SUBJECT: Responds to 960820 trip rept re audit of plant reactor & turbine bldg blowout panel calculations.

Subject: *Response to Trip Report for August 20, 1996 Audit of Reactor and Turbine Building Blowout Panels (Tac. No. M94858)*

**Response to Action Items from August 20, 1996
NRC Audit of Blowout Panel Calculations**

Fig. 4.13. Shear strength versus tensile strength. *Note.* Each point represents the average values of a specific bolt lot. The shear strength is computed on the relevant area, depending on the location of the shear plane.

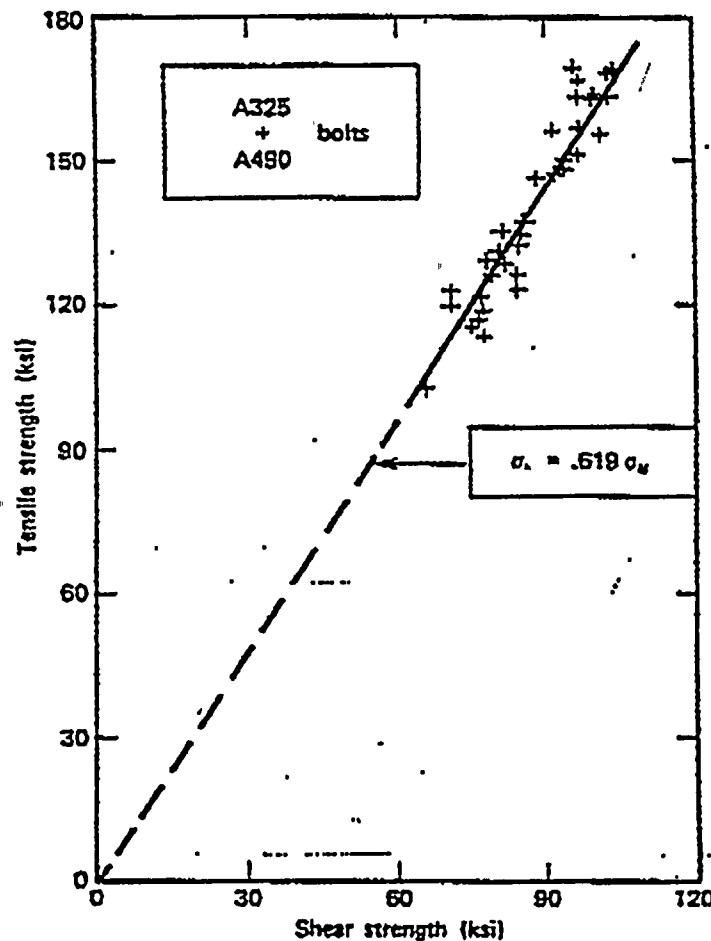
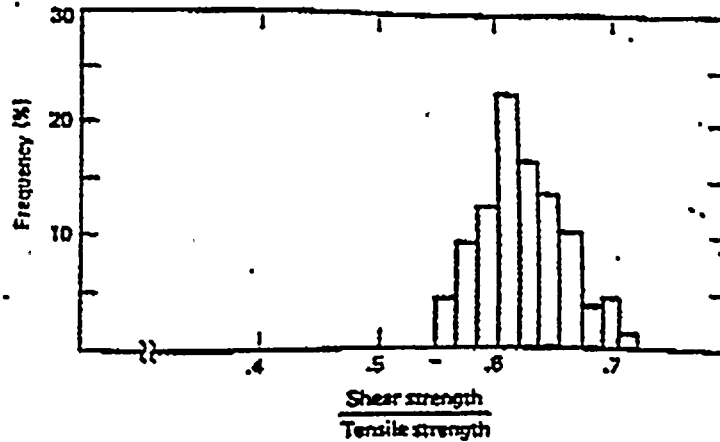
- Further explain the basis for using 0.62 tension allowable as the shear allowable, and further discuss the available test data.

A total of 13 bolts were tested to determine their tensile failure load. However, no bolts were tested to determine their shear failure load. As the bolts in the blowout panels are subjected to both shear and tension, Niagara Mohawk used the best available industry data identifying the correlation between shear and tensile failure loads in lieu of testing the bolts for shear strength. The reference used (identified below) concludes that the average shear strength of a bolt is approximately 62% of its tensile strength. This ratio of shear strength to the tensile strength was developed from test data acquired at the University of Illinois and Lehigh University as documented in the reference.

The variance of the ratio of the shear strength to tensile strength, as obtained from single bolt tension shear jigs, is shown in Fig. 4.14. A frequency curve of the ratio of shear strength to tensile strength was developed from test data acquired at the University of Illinois and Lehigh University. The average value is equal to 0.62, with a standard deviation of 0.03.
